RE: OBJECTION OF DEVELOPMENT APPLICATION DA2024/1838

We note the following objections for your consideration, addressing the Development Application [DA2024/1838](#) proposed at Address NSW 69 Clontarf St, Seaforth, NSW, 2092.

Image 1.1 – Source: 'Master Set' (p.7) – set back to be correctly accounted for, as has been recognised at 67 Clontarf.

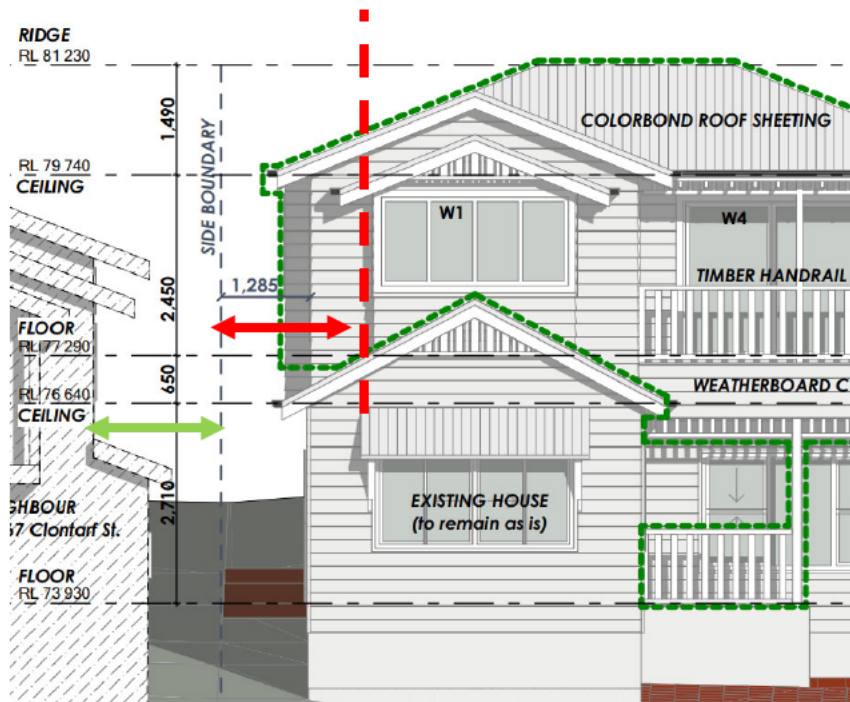
- The proposed first-floor addition does not comply with the minimum side setback requirements set out in the relevant planning controls. Specifically, Manly Development Control plan - Article 4.1.4.2 (c) requires "All new windows from habitable dwellings of dwellings that face the side boundary are to be setback **at least 3m from side boundaries**". The plans provided, as shown in Appendix 1.1, clearly show the setback to be only ~0.9m (1.285m to existing wall, with proposed 1st floor moving closer towards boundary), which is a notable breach of the prescribed setback distance.

- Furthermore, this same Article section (a) requires "Setbacks between any part of a building and the side boundary must not be less than **one third of the height of the adjacent external wall of the proposed building**". Per Appendix [image 1.2](#), as taken from the aforementioned article, this has not been considered in drawing the planned side set-back. Based on these calculations and the wall height of the proposed, the side setback to their southern wall on the first floor should be between 1.9m and 2.4m, which is substantially more than what they have proposed – it is more than double minimum controls. Given it is also a wall facing due south, these controls are even more critical to be respected and implemented.

- The subject site has adequate width to propose a set-back solution that meets the Applicant's brief while also complying with the controls. **Move the southern wall a minimum of 1.9m (or correct further measurement per council calculation) from the southern boundary, to comply with Council's controls.**
- Applicant to undertake a more detailed analysis of the proposed upper floor windows in relation to the neighbours windows and rooms beyond, to understand window placement and possible screening.

Image 2.1 – Source: 'Master Set' (p.8) – height control breach – total height exceeds 8.5m

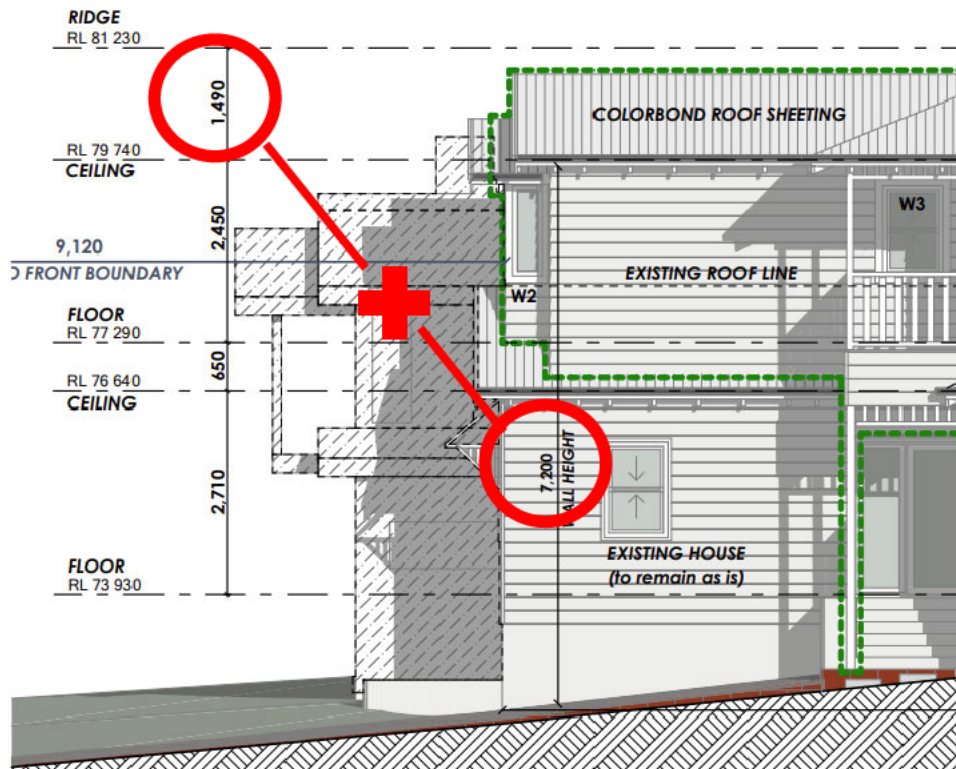
- The proposed development exceeds the prescribed maximum height limit established under the Manly LEP Plan 2013, section 4.3 (2), which requires "The height of a building on any land is not to exceed the maximum height shown for the land on the Height of Buildings Map" - Per Height of Buildings Map Sheet HOB_001, Clontarf street falls under category 'I' with **maximum residential building height of 8.5m**. The submitted drawings, as shown in [Appendix Image 2.1](#), indicate a maximum height of 8.69m, which is in violation of the height control. Although this is at the apex of the proposal, the wall height breach has lifted the entire proposal, where the floor, windows, eaves and roof height sit. The total breach of 190mm should not just be considered, but the knock-on effect this has on every level and building element.

- Additionally, the height indicated in the drawings provided in [Appendix Image 2.1](#) conflicts with the height description in the Statement of Environmental Effects (SEE). The SEE (p.4) notes that the maximum building height to the highest ridge is 8.25m, which is inconsistent with the RL calculations, further demonstrating non-compliance with the stated height limitations.

- Applicant to consider **reducing floor to ceiling heights and the roof pitch**, which will aid in alleviating the overshadowing and privacy impacts.
